Re: Home2 Suites By Hilton – PL2024097 Response Letter

This letter is in response to the Commercial Final Development Plan Applicant's Letter dated May 17, 2024. The engineering plans have been revised to address the comments. The original comments are below and follow the order as shown in the review comments. Our responses are in bold, and follow each individual comment.

Project Name: Home2 Suites  
Project Address: 251 NE Alura Way, Lee's Summit, MO 64086  
Plan Number: PL2024097

## SOUTH ENTRANCE - LEFT IN

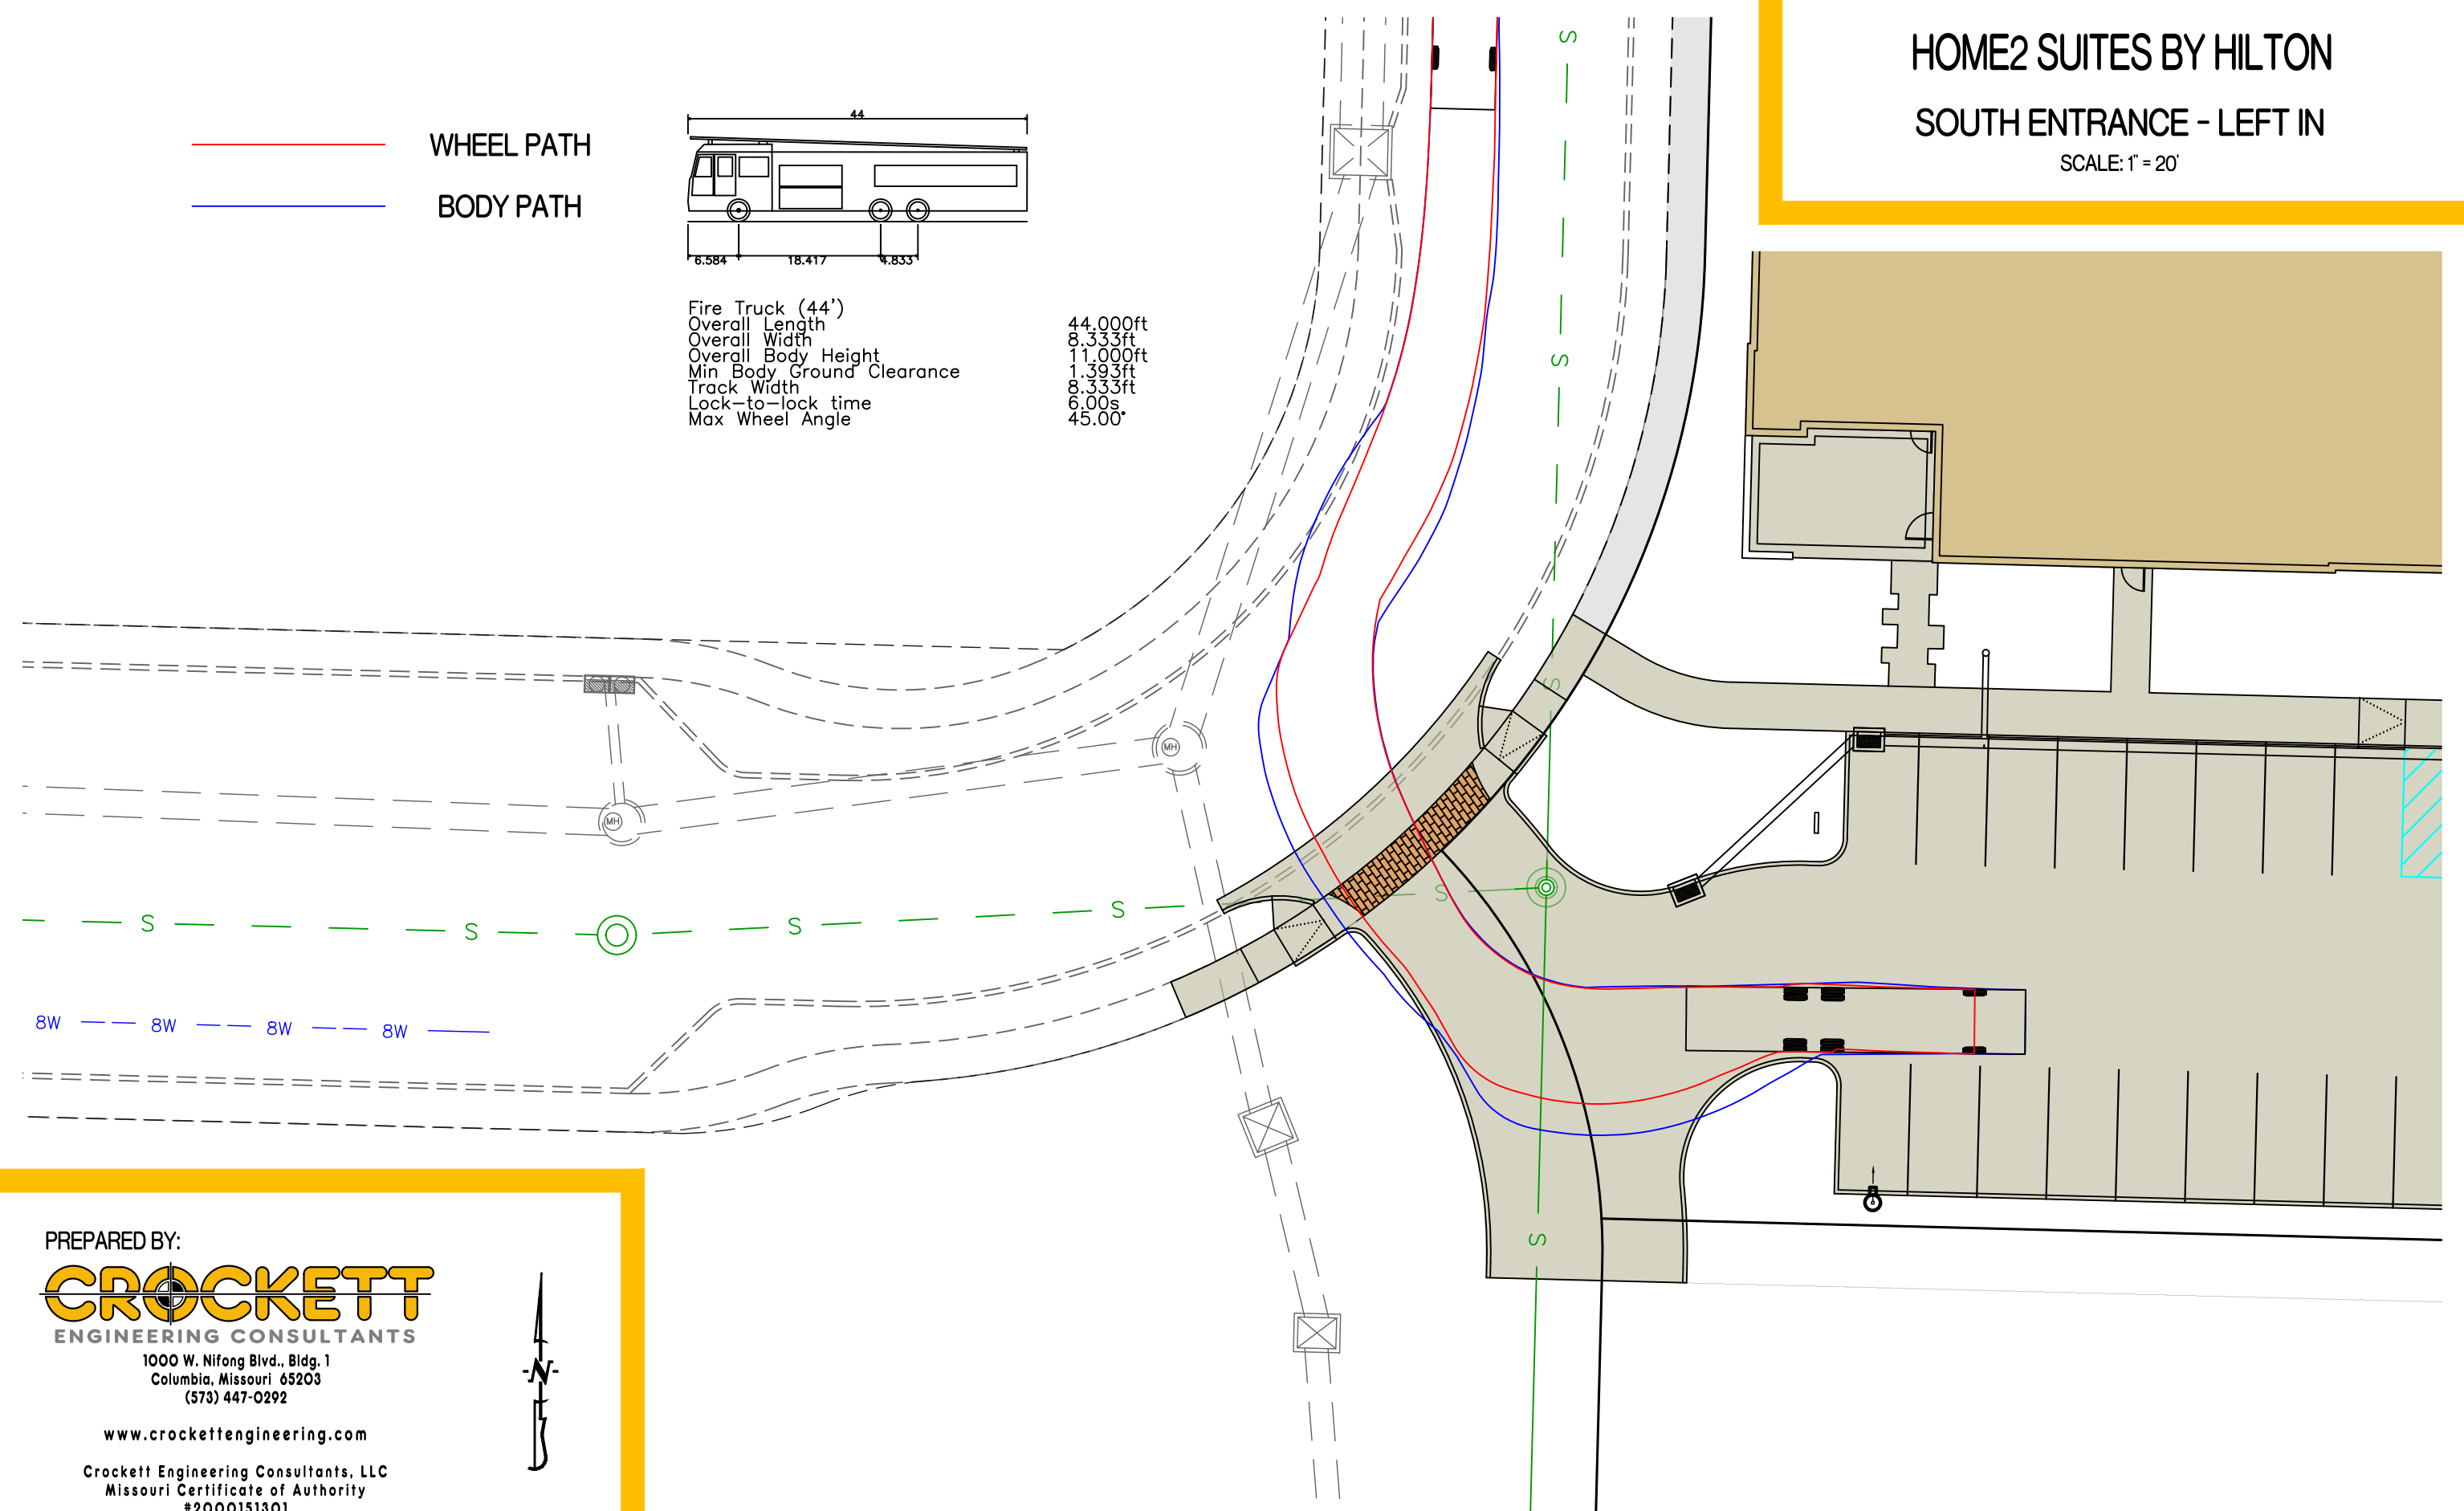
1. The current radii do not meet the City's design criteria for Commercial/Industrial Collector or Local roads. If you are not able to adjust the radii due to storm or other public site restrictions an exception may be allowed, otherwise site approval will not be given to the current design.

Please see attached revised exhibits. A 15' radius will still allow a firetruck to enter and exit these locations without bumping into the proposed curb. The red line shows the wheel paths of each movement shown.
